# FIRE SAFETY INSPECTION REPORT

## Unity Fabric Industries Ltd (Unit-2)

**ACCORD ID: 23652**

**Date: 15 July 2019**

## F-2 Egress

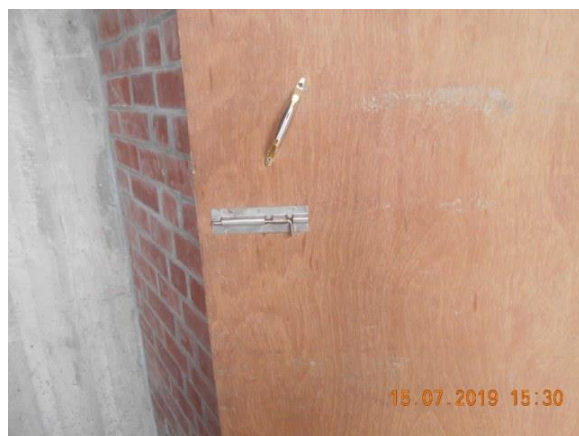
Exit doors on several floors with slide bolts are provided at Exit stairs & along egress path.

Remove slide bolts or Locking features from all egress gates.

If locks are required for security reasons, utilize special door locking features complying with ACCORD standard 6.8.2.
